Environmental Impact Statement Report under the *Environmental Protection Act 1994*

Minyango Project
Proposed by Blackwater Coal Pty Ltd

Prepared by: Statewide Environmental Assessments, Department of Environment and Heritage Protection

March 2014

Figure 3 Predicted maximum vertical subsidence (source: EIS Figure 6-2)

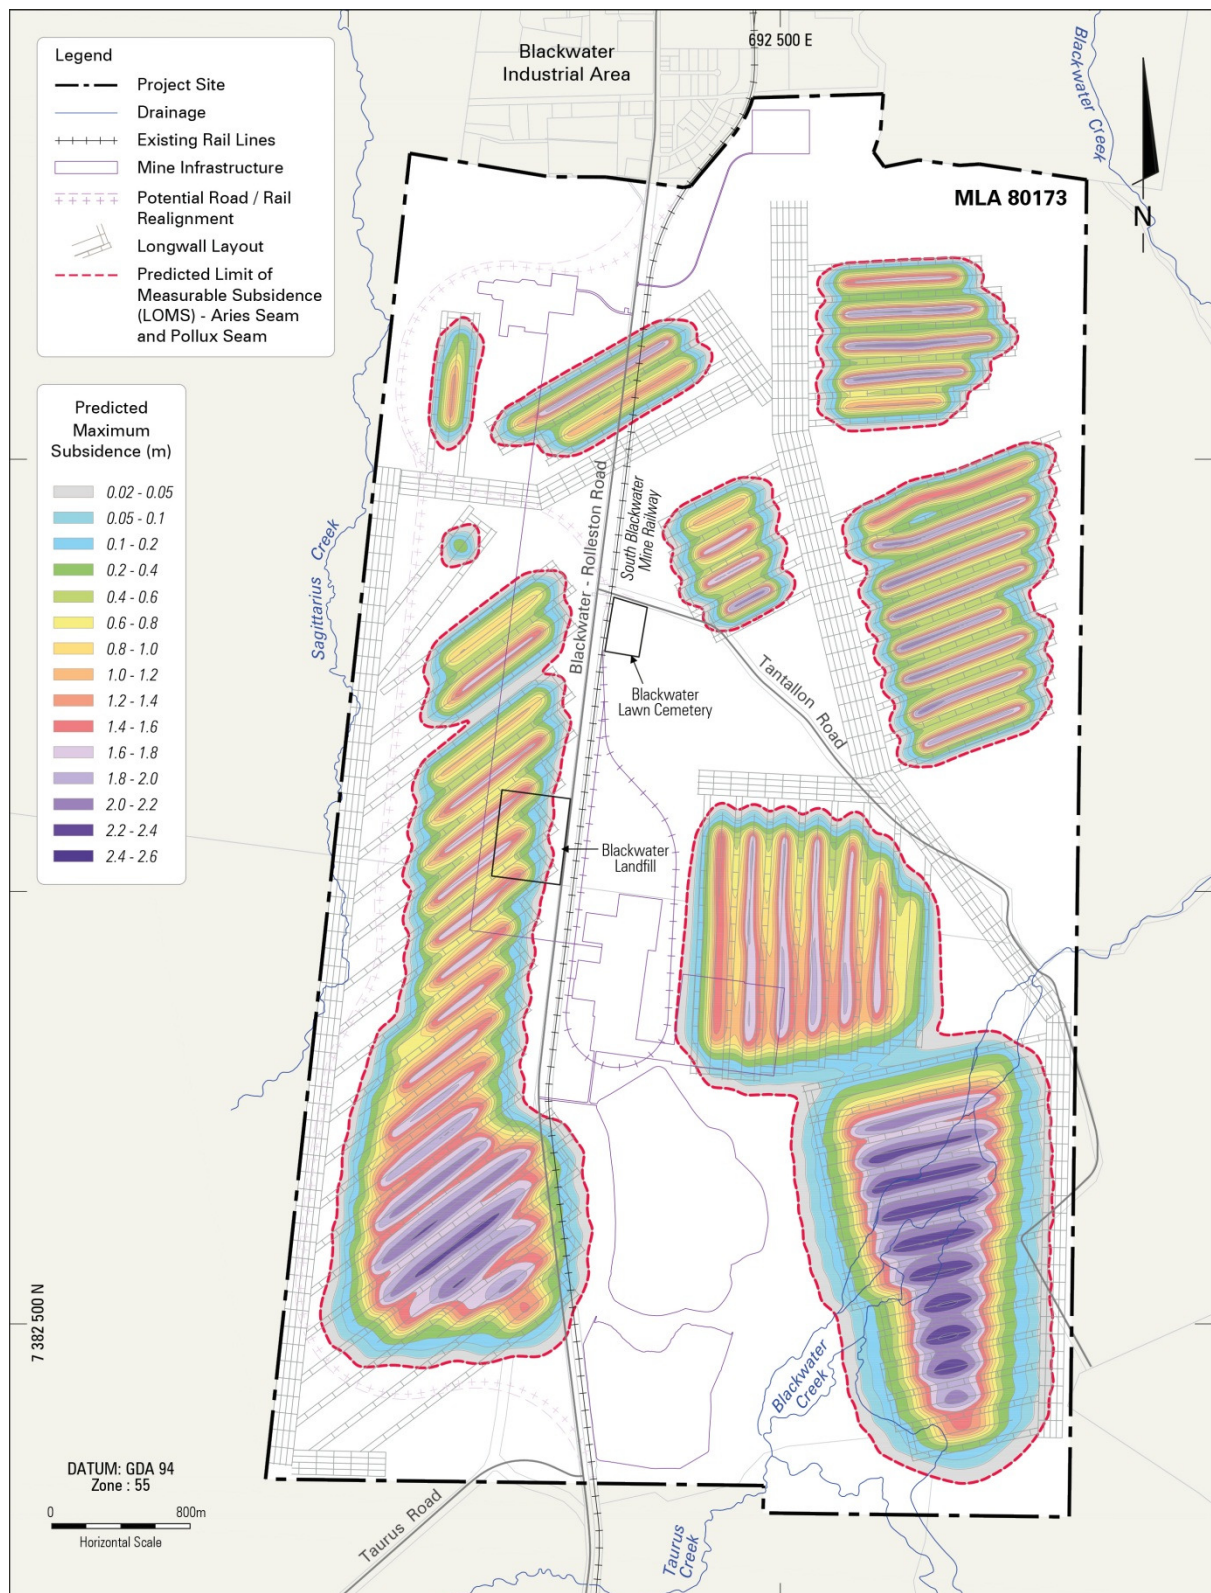
1. No surface subsidence outside the project site boundary.
2. A total surface area affected by mine subsidence of approximately 1354ha (i.e. the area within the predicted limit of measurable subsidence (LOMS); Figure 3).

3. Vertical subsidence of up to 2.5m. The predicted maximum vertical subsidence after mining in the Aries Seam was 1.2m and 2.5m after mining both the Aries and Pollux Seams respectively (Figure 3). The maximum vertical subsidence was predicted to occur in the south-east of the mining area where the depth of cover is the deepest.

Tantallon Road [CHRC]	A small section of this road (<200m) is within the predicted LOMS. EIS Figure 6-2 indicates it may be subsided by ~ 0.02–0.05m.	It was stated in the EIS that should detailed investigations undertaken in consultation with owners identify that managing subsidence in-situ is not feasible then realignment of Blackwater-Rolleston Road and/or South Blackwater Mine Railway may be required. The EIS identified a conceptual realignment of Blackwater-Rolleston Road and the South Blackwater Mine Railway within the project site along the western boundary which is beyond the predicted LOMS.
South Blackwater Mine Railway [Aurizon]	~ 0.55m of the railway in the north of the MLA is within the predicted LOMS, with subsidence of 0.02–2m predicted. ~ 1.2km of the railway in the south of the MLA is within the predicted LOMS, with subsidence of 0.02–0.06m predicted.	
Stockroute [DNRM and CHRC]	~ 2km of the stockroute in the north and south of the MLA is within the predicted LOMS. Subsidence of up to 2.2m is predicted.	Proponent proposes to manage the impacts of subsidence on the operation of the stockroute through agreements between the owners of the stockroute (i.e. DNRM and the CHRC). See section 4.10, Land of this assessment report for further information.

Figure 6 Predicted post mining flood level impacts—50 Year ARI flood event (source: EIS Figure 11-5)

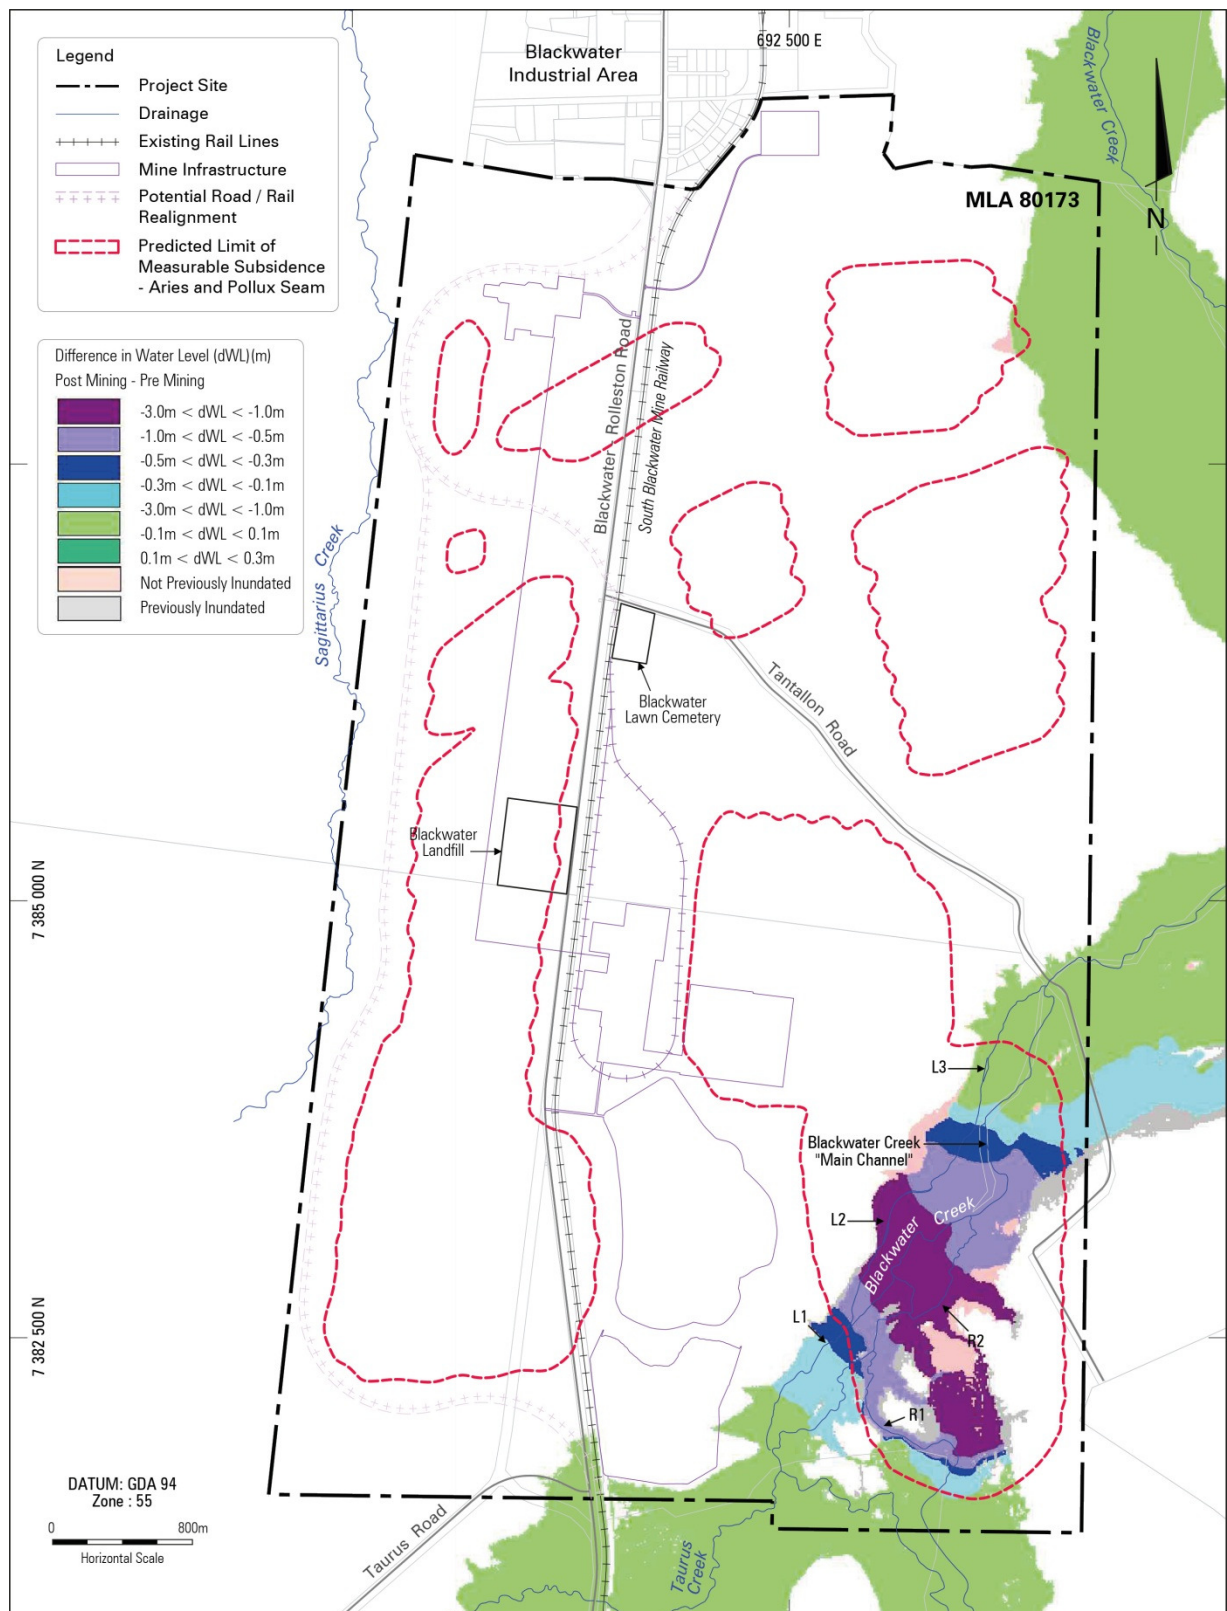
- **For Blackwater Creek:**
 - Peak 2 year and 50 year ARI flood levels (Figure 6) were predicted to decrease across the surface subsidence area of Blackwater Creek by a similar magnitude as the predicted maximum subsidence of the bed level (a maximum of 2.7m and 2.1m for the 2 and 50 year ARI respectively).

- Some minor increases⁶ and reductions⁷ in the extent of flooding along Blackwater Creek and its channels were predicted in the 50 year ARI flood event (Figure 6).

<p>General recommendation 4: The proponent liaises with TMR to agree on acceptable stormwater discharge volumes at the Capricorn Highway as a result of any discharges of water from the mine into Blackwater Creek.</p>
